**Subject: Mountain Ash Limited Partnership, Summit Pit application to AEP,**  
Location (W1/2 31-026-03-W5). DAPP0001717 & EMS 001-00481044

### **Summary**

This submission is my Statement of Concern which is provided to Alberta Environment & Parks expressing my serious concerns about the proposed Mountain Ash Summit gravel mine as it will impact on Big Hill Springs Provincial Park. I herewith as a senior-level geologist provide my technical analysis of the relevant ground water issues. *My recommendation is that the Summit gravel mine be not approved.*

Figure 1. From: Mountain Ash Website. SLR Consulting (Canada) Ltd. Report: Mining & Excavation Plan for the Mountain Ash Limited Partnership, Rocky View County, Alberta, April 2021, Revision 1 - August 2021, Revision 2 - December 2021

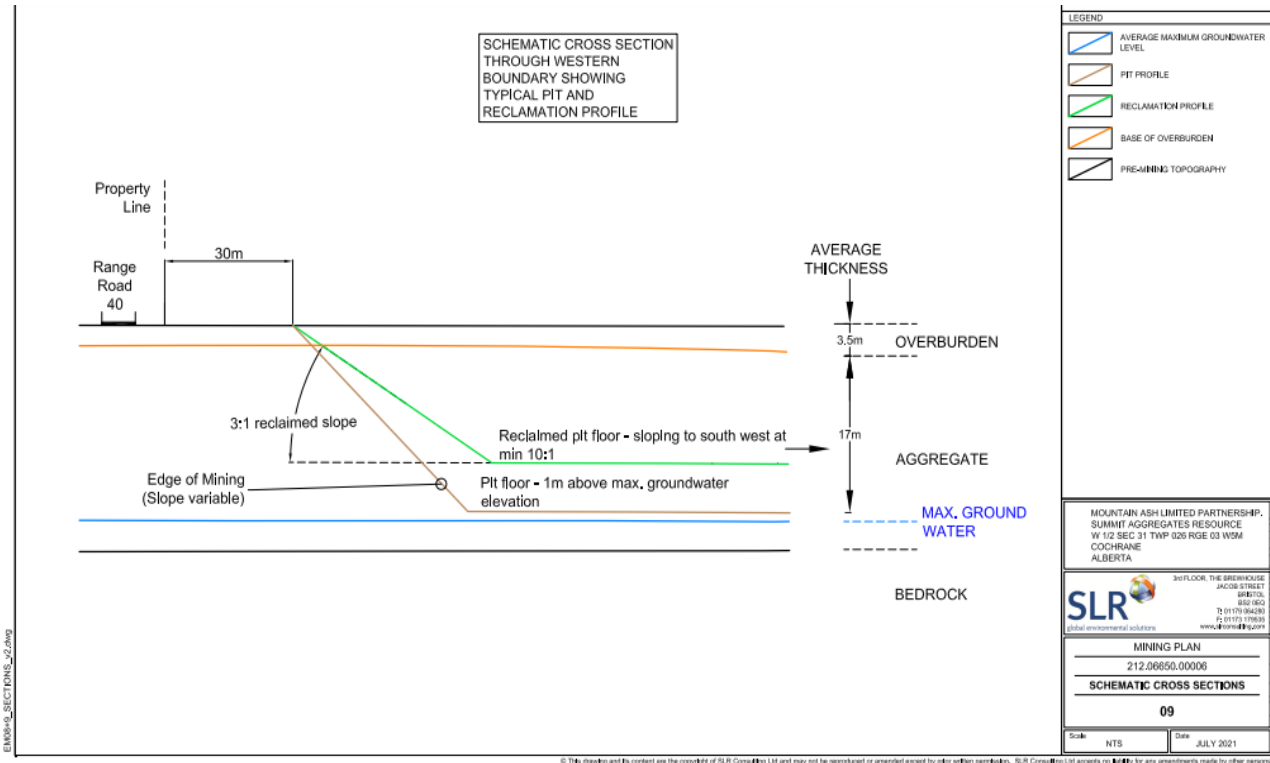
My view as a senior-level geologist with five decades of work experience is that the Mountain Ash gravel mine will cause irreparable damage to the springs at Big Hill Springs Provincial Park. As shown in Figure 2, below, Mountain Ash shows that they will excavate an average of 20.5 meters (67.2 feet) of overburden and gravel. Of key relevance, however, is that the gravel deposit underlying the Mountain Ash land is exceedingly thick and rich in gravel and there will be great economic incentive for Mountain Ash to evacuate much more than the 20.5 meters (67.2 feet) of overburden and gravel. Accordingly, the maximum thickness excavated could be up to 30 meters (100 feet) of overburden and gravel. The environmental impact of this on the area's ground water will be huge.

As shown in SLR Consulting's Schematic Cross Section 09, please refer to Figure 2 below, the pit's floor will be 1 meter above the maximum ground water elevation. My view is that this is a very serious concern based on the known information on the ground water in this area. Ground water in this area is of two sources:

Tako Koning, Senior Geologist has analyzed this data shown above in Figure 1 from SLR Consulting. He notes that an average thickness of 3.5 meters (11.5 feet) of overburden will be removed and an average of 17.0 meters (55.8 feet) of aggregate will be removed. Accordingly, an average total thickness of 20.5 meters (67.2 feet) of overburden and aggregate will be removed. This thickness is equivalent to the height of a 6-story building. This is the *average* amount of thickness to be removed. The maximum thickness to be removed may be substantially greater and will add to the serious impact on the ground water flowing downstream into Big Hill Springs Provincial Park and into Bighill Creek which drains down into Cochrane and into the Bow River.

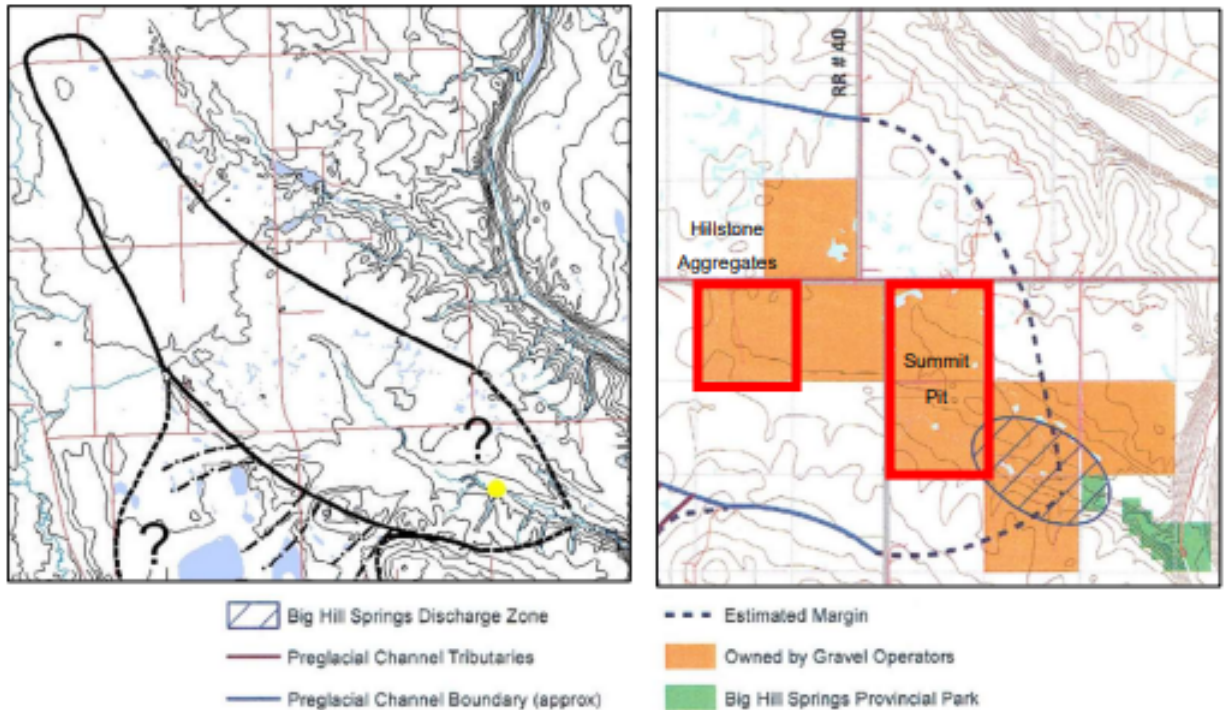
**Figure 1.** Mapped preglacial channel for Big Hill Springs (left)<sup>1</sup>, where dot-dashed lines indicate extent of buried tributaries, and extent of lands owned by gravel operators near Big Hill Springs Provincial Park (right)<sup>2</sup> *Note: MALP property outlined in red.*

Figure 2. From Dr. Jon Fennell, PhD., P. Geol. Internal Report, June 23, 2021, reproduced with permission. The left map is from Soren Poschmann's 2007 University of Calgary thesis for the Department of Geology and Geophysics, University of Calgary. The map to the right is a topographic map with the land owned by gravel mining companies highlighted in orange. Mountain Ash's proposed Summit Pit is outlined in red. The Big Hill Springs Discharge Zone extends into the eastern margin of the Summit pit. Also outlined in red is the active gravel mine operated by Hillstone Aggregates. The quarter-section owned by McNair is northeast of the Hillstone mine. LaFarge Canada is owner of the quarter-section east of the Hillstone mine and west of the proposed Mountain Ash Summit pit. Burnco Rock Products Ltd owns the 3 quarter-sections of land east of the proposed Mountain Ash Summit gravel pit. Burnco's land directly overlies the Big Hill Springs Discharge Zone.
